PCN: V15-002-F48070-MA

Product Change Notice

Issue Date: 09 June 2015

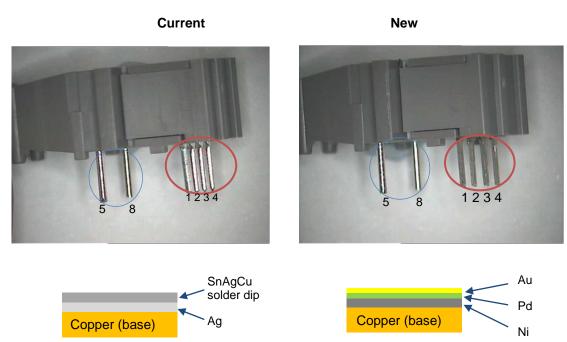
Qualify NiPdAu pre-plated lead-frame to improve product reliability and product cycle time and to simplify lead-frame supply chain.

Active pins (pin1 to pin4 in red circle): Affected by changing to new NiPdAu lead-frame finish.

Housing staple pins (pin5 and pin8 in blue circle): No Change.
